Response to the Anonymous Referee #2

General Comments. This paper develops a county-level flood protection level (FPL) dataset for China on the basis of the prescriptions of the 2014 Chinese policy document Standard for flood control. It then analyses this against the amount of children and elders in the country, also by county. The paper is generally well written, and even though I do not think it can be considered particularly substantial as a research article (as the bulk of the work consists in essentially overlapping GIS datasets following a policy document), I believe the results are nevertheless interesting and useful to the community. Thus, in my opinion the article may be considered for publication in NHESS, although several improvements are necessary.

Figure 1 The number of counties with different flood protection levels. (The map of western and eastern China is shown in Figure 3)

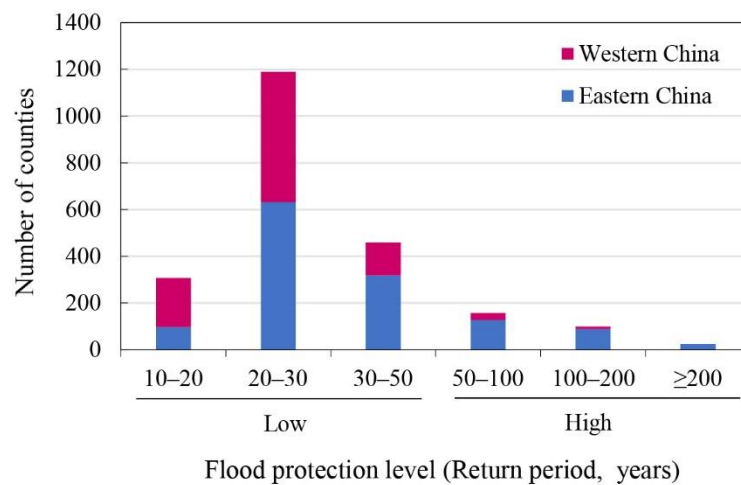
***Specific comments 11.*** Figure 2: Remove "the" in y-axis label.

Accepted: Thanks for the suggestion for Figure 2. This label has been corrected. Please check from *lines 526–527 on page 24*, or as below.
